Response dated: 27th October 2025

Reference: SO/2025/124668/02-L01

‘Demolition of buildings and erection of 87 no. Affordable dwellings and associated access off Dumers Lane, landscaping and parking. Land adjacent to Bealey Industrial Estate, Dumers Lane, Radcliff, Manchester, M26 2BD’.

Figure1: Climate Change Allowance for Peak River Flow

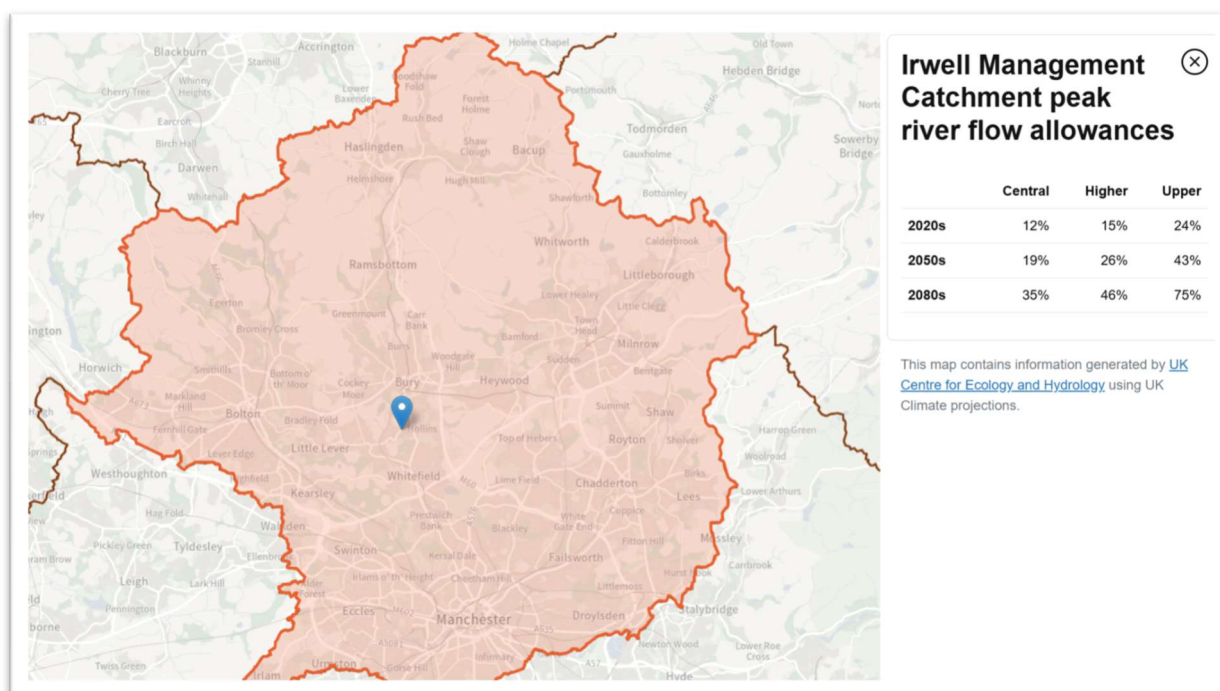
- 1. Climate Change Allowances - It is important to highlight that current flood zone designations do not take account of climate change. Therefore, the FRA must incorporate climate change allowances in line with the latest guidance - Flood risk assessments: climate change allowances - GOV.UK . Where we are unable to provide 1% Annual Exceedance Probability (AEP) climate change model outputs, it is the applicant’s responsibility to undertake and submit appropriate hydraulic modelling for our review.***
The FRA currently bases design flood levels on a 0.5% AEP event, confirming the unavailability of the 1% AEP climate change data. This approach is not acceptable. Planning Practice Guidance (PPG) and the NPPF clearly state that for developments at risk of fluvial flooding, the 1% AEP event plus appropriate climate change uplift

must be assessed. FFL's are proposed to be set 700mm above the 0.5% AEP level. While this may appear conservative, it does not provide assurance that the development would be safe under the 1% AEP climate change scenario. Therefore, an updated FRA must be submitted using appropriate AEP's and climate change.

Townsend Water Engineering (TWE) have undertaken a review of the flows provided by the Environment Agency (EA). As suggested, TWE has taken the climate change allowance from 'Climate Change Allowance for the Peak River Flow'¹. This states that for housing, the climate change should add an additional 35% to the flow of the 1% AEP event. Please see figure 1 for the climate change allowances:

To calculate the 1% AEP plus climate change event, TWE have multiplied the 1% AEP flow event by 1.35 (this increases the flow of the 1% AEP flood event to the 1% AEP plus climate change flood event) and then compared the flows with the 0.1 AEP flood flow event. If the flows are comparable, the 0.1% AEP event will be used for the 1% AEP plus climate change event. Please see the node map indicating the position of the flooding nodes.

Figure 3: Levels Around Site

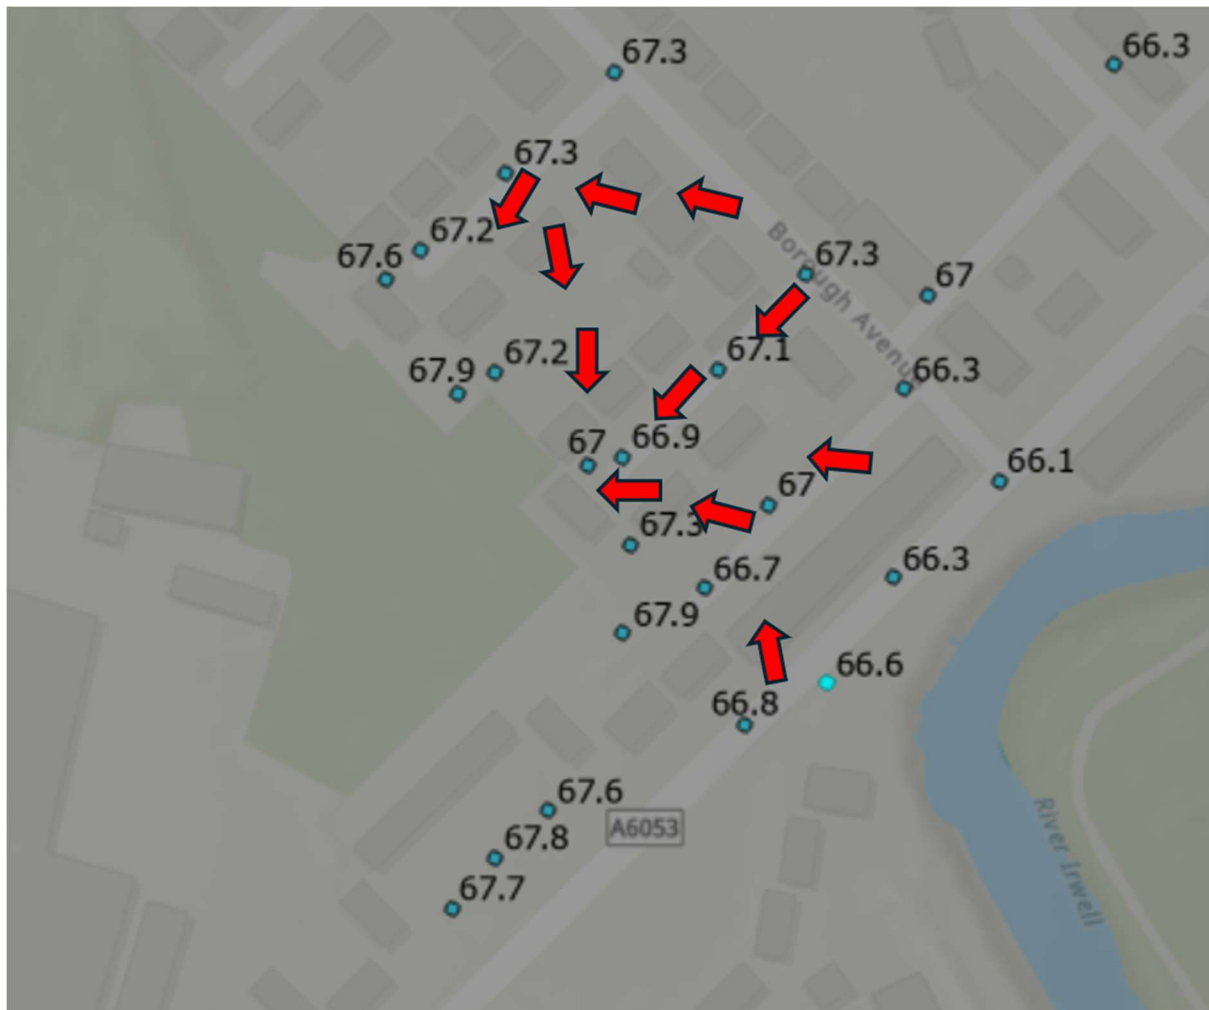
3. ***Residual Risk and Climate Change - We have reviewed the modelling for this location both current published and unpublished internal EA modelling which is not currently available for external distribution. Based on our assessment, there remains a significant residual risk to the development site. In accordance with the National Planning Policy Guidance (NPPG), the FRA must address residual risk scenarios, including defence overtopping, breach, and failure. The assessment must include relevant data such as flood depth, velocity, and duration, and these should be illustrated using hazard curves consistent with Environment Agency guidance (FD2320).***

Reviewing the topography compared to the 1% AEP plus climate change event indicates that the majority of the site is not at risk of fluvial flooding in the 1% AEP flood event plus climate change. Please see Figure 3 indicating ground levels from LiDAR around the site. The levels indicate that the site potentially only floods from the east.

Table 3: SFRA red line Boundary compared to Proposed Site Boundary

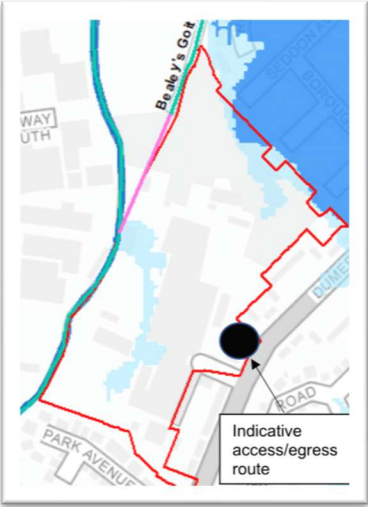
Reasons: *The FRA currently references flood zone information from 2024. However, the most up-to-date data, including the latest National Flood Risk Assessment (NaFRA) outlines, must be used for any assessment. Please can the FRA be updated accordingly.*

It should be noted that the SFRA site was for a much larger site. The western section of this site assessed in the SFRA (the former paper mill) is next to Bealey's Goit and Hutchinson's Goit. Please see below a comparison of the redline boundary of the SFRA redline boundary and this planning application.

The areas pertaining to Bealey's Goit and Hutchinson's Goit in the SFRA are not within this proposed development.

Therefore, according to the Appendix A of the SFRA, the LPA have decided that the proposed site has passed stage 2 of the exception test as this part of the site is not effected by flooding from Hutchinson's Goit. Please see the full exception test in Appendix A.

Drawing Title:
PROPOSED SITE LAYOUT
ON TOPOGRAPHICAL SURVEY
WITH SLAB LEVELS

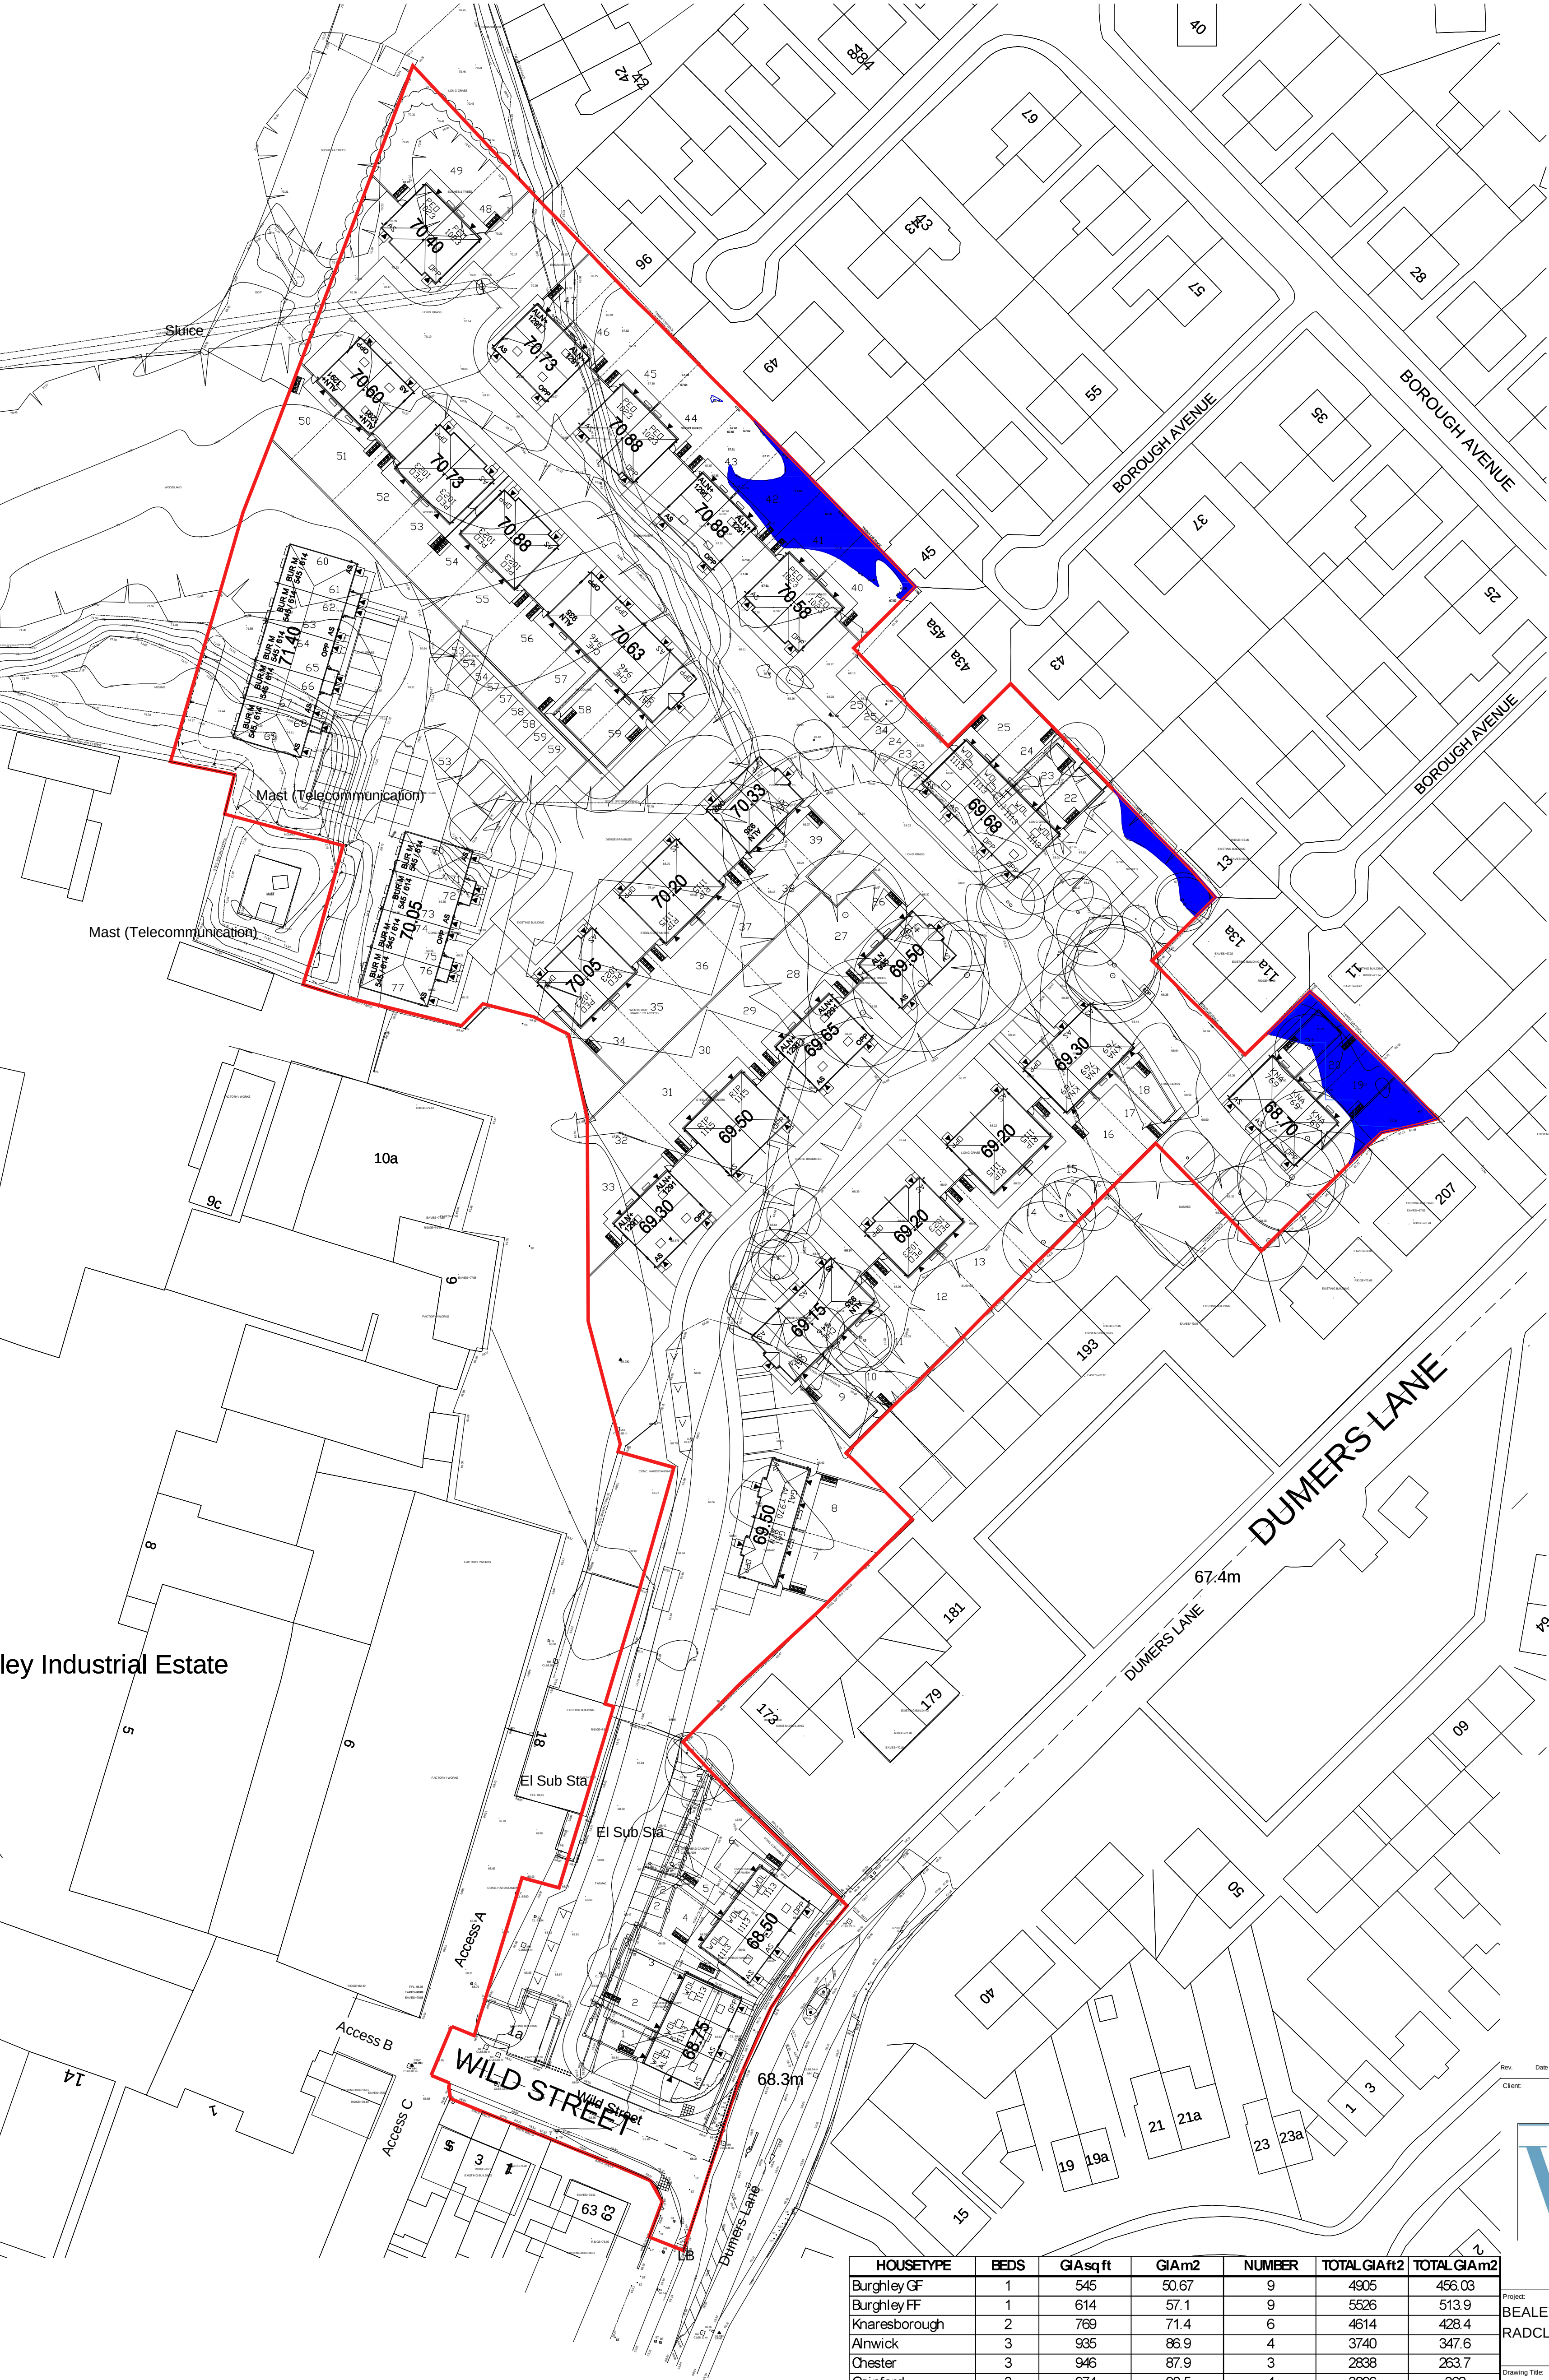
Finally, please could clarification on “Burghley” drawing reference “BUR-M-113” be provided on a site plan. There is ground flood sleeping proposed so this must be accounted for in an Flood Warning, Evacuation Plan (FWEP).

As discussed in question 3, all the dwellings / maisonettes are outside of the 0.1% flood event and the 1% flood event plus climate change envelope. To further protect the maisonettes, please see below the extracts of the finished floor levels overlaid by the topographical survey.

The proposed buildings are outside of the flood outline (please remember this site only floods if the defences fail), and are 1m above the flood level. An access and egress and emergency plan is not required because the houses do not flood.
